CITY OF LOS ANGELES
INTER-DEPARTMENTAL CORRESPONDENCE

905 S Beacon Av
DOT Case No. CEN20-49088

Subject: **TRANSPORTATION ASSESSMENT FOR THE PROPOSED MIXED-USE PROJECT LOCATED AT 905 SOUTH BEACON AVENUE (PAR-2019-7619-TOC)**

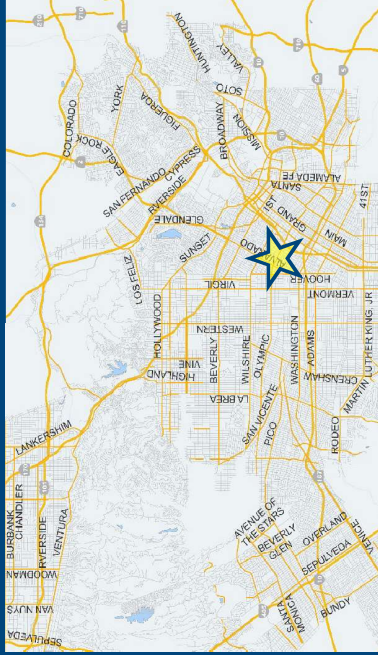
The conceptual site plan for the project (see **Attachment A**) is acceptable to DOT. The project would be accessed via a full-access driveway along Beacon Avenue and a full-access driveway along James M. Wood Boulevard. Truck loading access would be provided by the driveway along James M. Wood Boulevard. Review of this study does not constitute approval of the dimensions for any new proposed driveway. Review and approval of the driveway should be coordinated with DOT's Citywide Planning Coordination Section (201 North Figueroa Street, 5th Floor, Room 550, at 213-482-7024). In order to minimize and prevent last minute building design changes, the applicant should contact DOT for driveway width and internal circulation requirements prior to the commencement of building or parking layout design. The applicant should check with City Planning regarding the project's driveway placement and design.
